CITY OF LEWISTON
PLANNING BOARD MEETING
Monday, May 13, 2013 – 5:30 P.M.
City Council Chambers, First Floor
Lewiston City Building
27 Pine Street, Lewiston

TO: Planning Board
FROM: David Hediger, City Planner
DATE: May 10, 2013
RE: May 13, 2013 Planning Board Agenda Item IV(a)

An application submitted by Stoneybrook Consultants on behalf of K.P. Realty, LLC to construct a Dunkin Donuts Shop at 743 Sabattus Street.

TO: Stoneybrook Consultants, LLC
FROM: David Hediger, City Planner
DATE: May 1, 2013
RE: Sabattus Street Dunkin Donuts

SHEET TITLE: **SITE PLAN**
 PROJECT: **DUNKIN' DONUTS**
 141-143 SABATTUS STREET - LEWISTON, ME
 CLIENT: **KP REALTY, LLC**
 1385 MAINE STREET #1 - FOLAND, MAINE 04274
 SCALE: 1" = 20'
 DATE: MARCH 2013
 DRAWN BY: KRF
 CHECKED BY: WMP

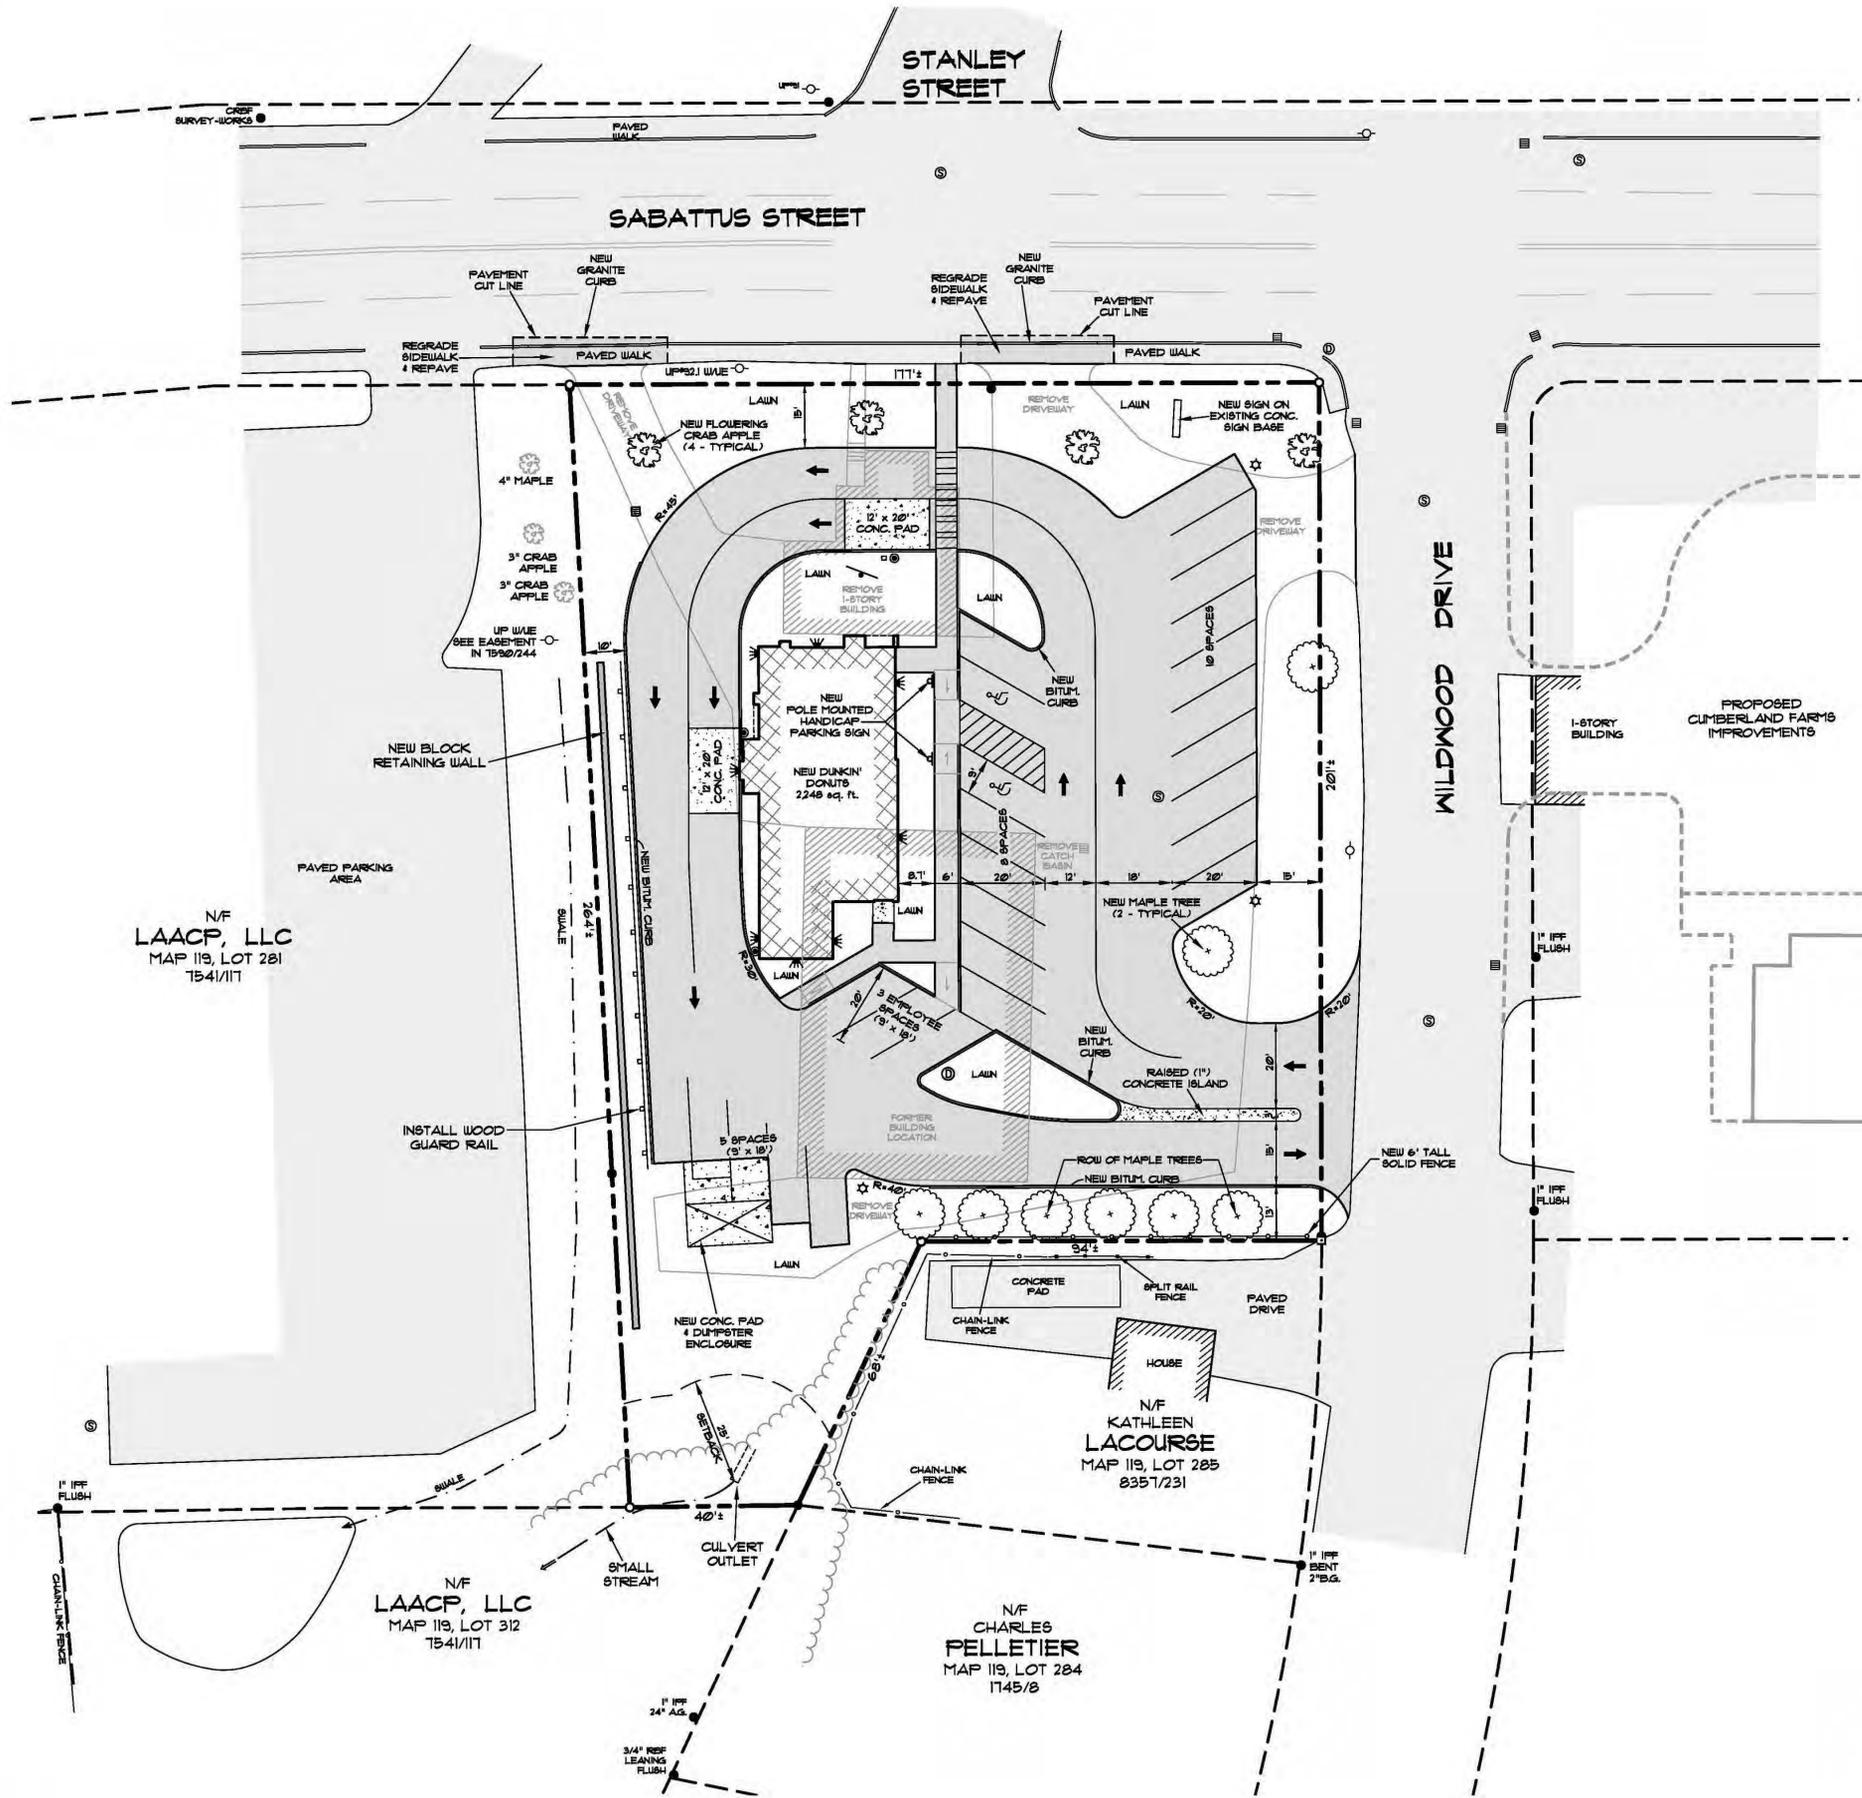
13. There appears to be a grading typo behind the dumpster with the 258' elevation.
14. Detail on the dumpster screen should be provided.
15. Sheet 1 legend must be revised with respect to proposed landscaping. Please confirm plantings must be 2.5" caliper upon planting.

3. You have noted in your May response that lighting will be cut off fixtures and pole lighting height will not exceed 20'. Since plan details are not being provided, this should be noted on Sheet 1 within the legend provided.

GRADING & UTILITY PLAN

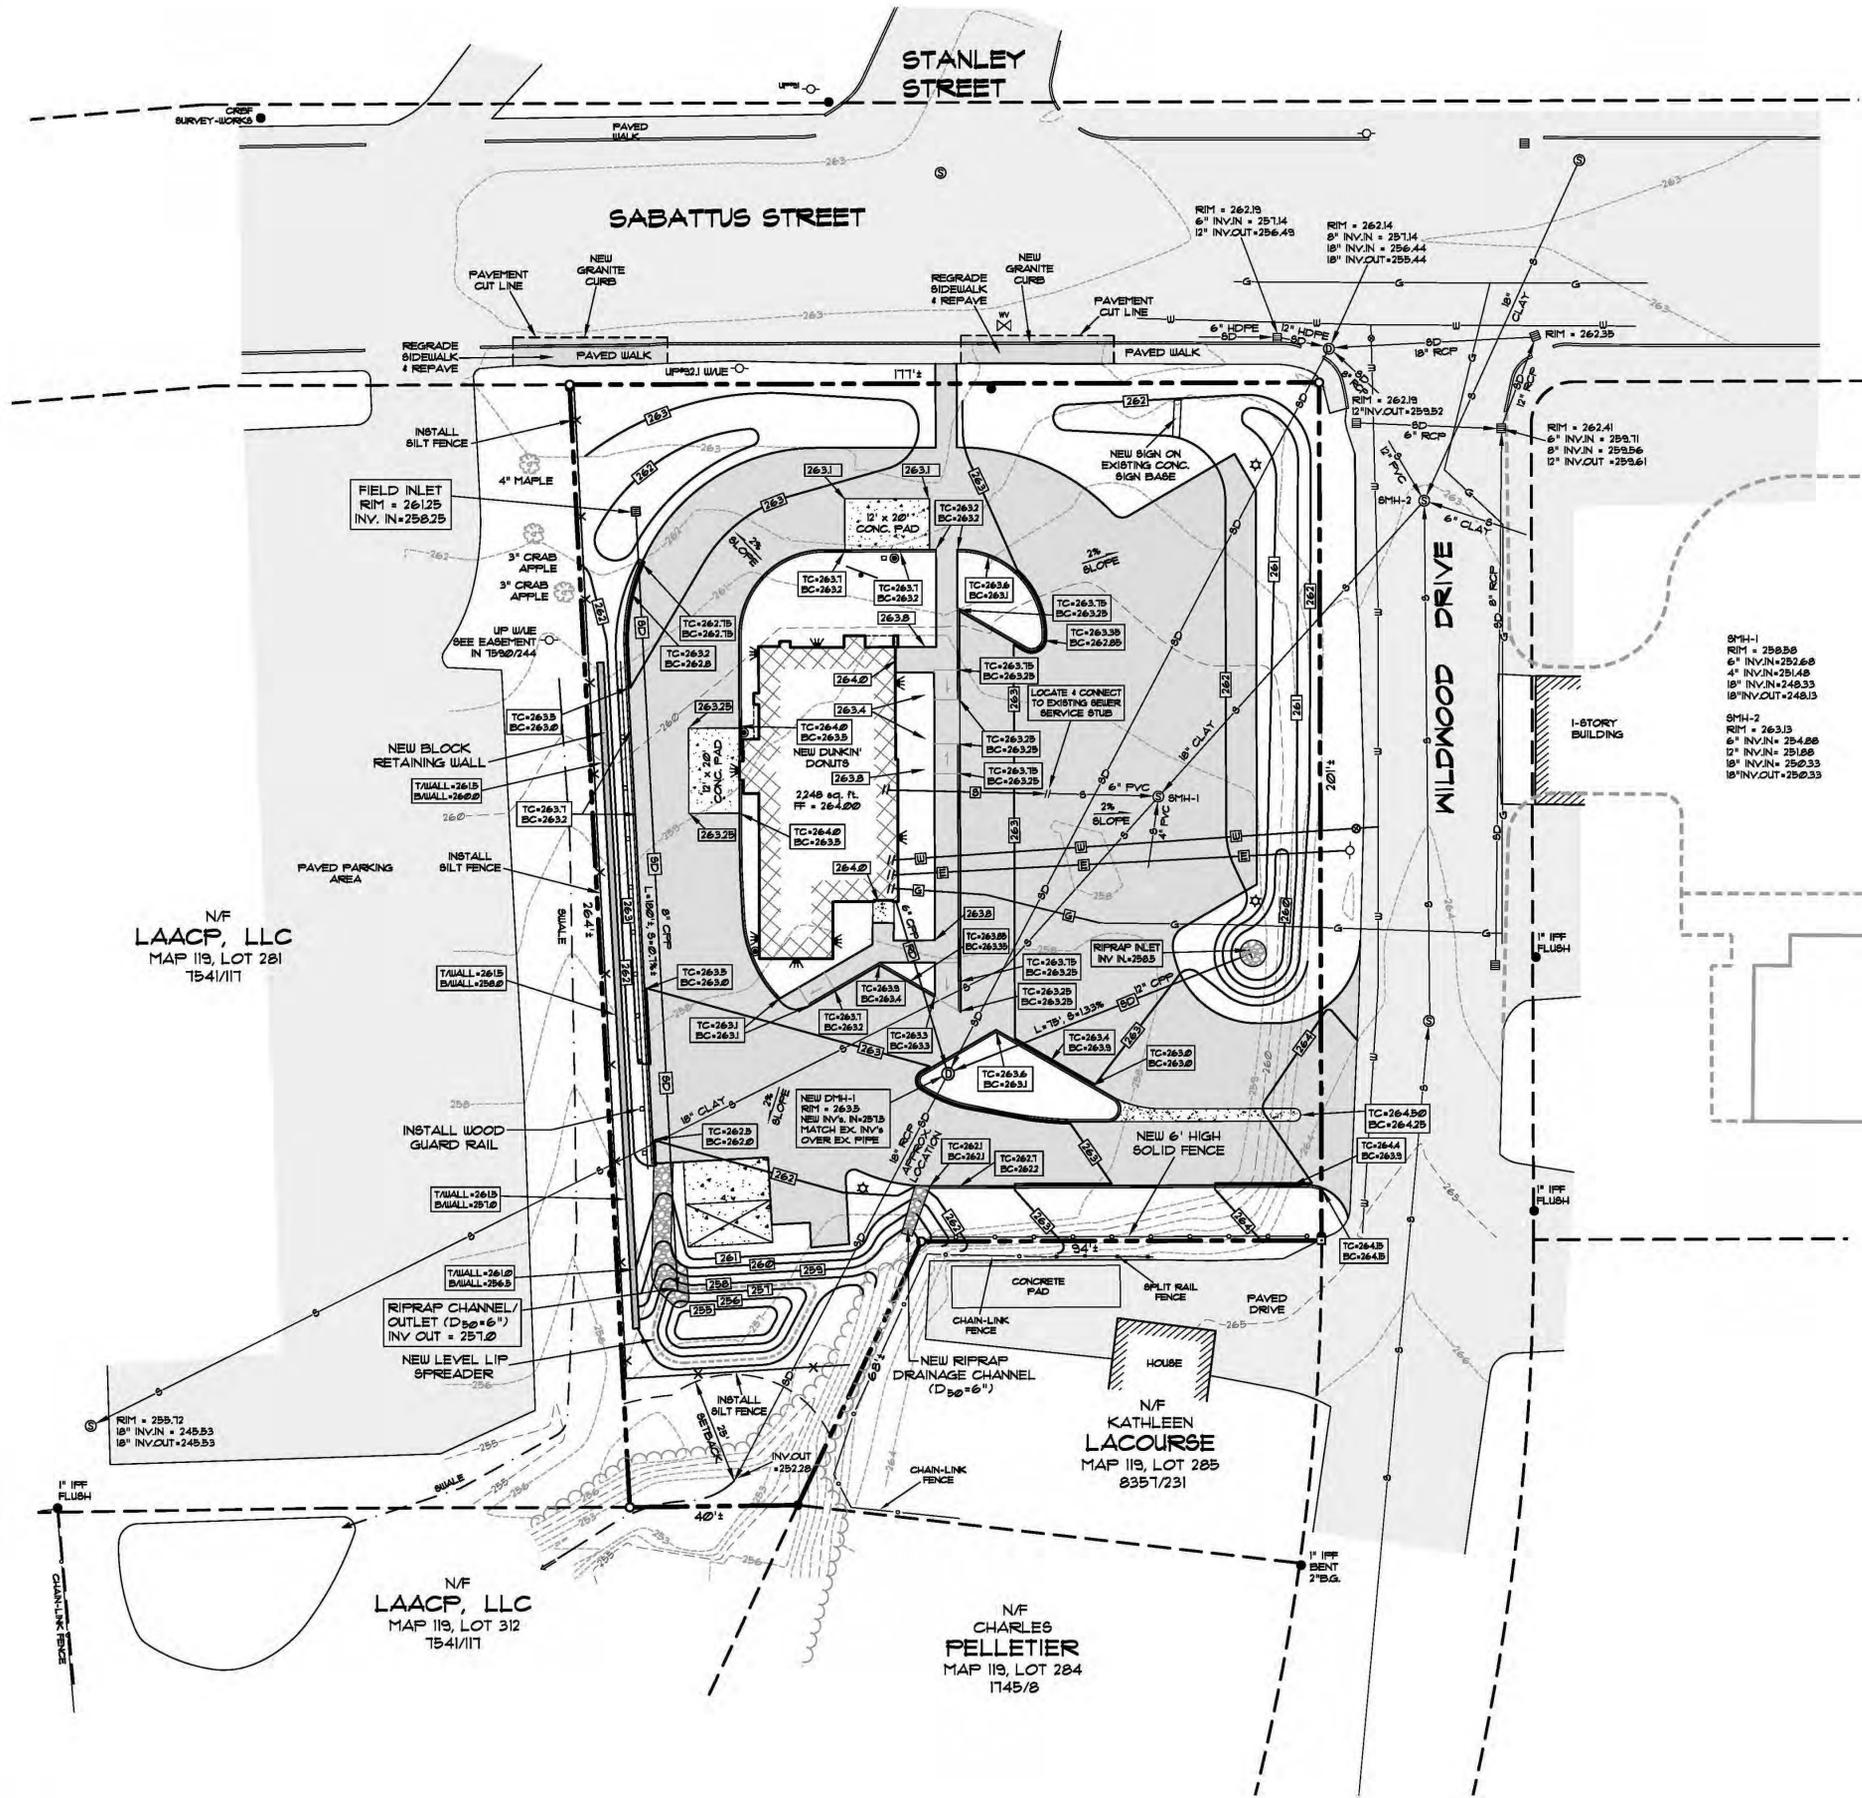
1. Sheet 1, note 6 and Sheet 2, note 5: these notes do not seem necessary at this point in the review.
2. Sheet 3, erosion control note 1: the note references weekly inspections will be conducted for erosion control purposes. Staff is recommending that upon construction activity commencing, weekly erosion control reports are provided to city on the status of the project and any issues or corrections needed or made with respect to erosion control.

NEW "DOGHOUSE" MANHOLE CONNECTION TO EXISTING STORM DRAIN
NOT TO SCALE

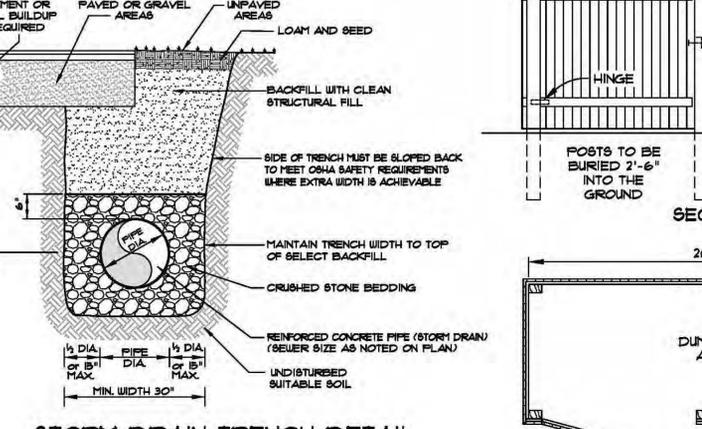
8. A detail for a manhole should be added to the detail sheet. The applicant should consider utilizing a doghouse structure and maintaining the bottom of the existing pipe as the channel and construct the shelf around the pipe instead of trying to make connections using short sections of pipe that could leak over time.

2. The detail for the manhole shall be revised to include a brick channel.
3. The detail for the Rip Rap Swale indicates a 12" thick layer of rip rap, typically rip rap is placed at 2.25 times the d50 stone therefore this should be a 15" layer.
4. The detail for the Rip Rap Swale indicates the use of Mirafi 700x geotextile, this is a woven geotextile, typically non-woven geotextiles are used under rip rap.
5. Due to the nature of the establishment a permit will be required from the Lewiston Auburn Water Pollution Control Authority (LAWPCA) regarding the handling of grease.
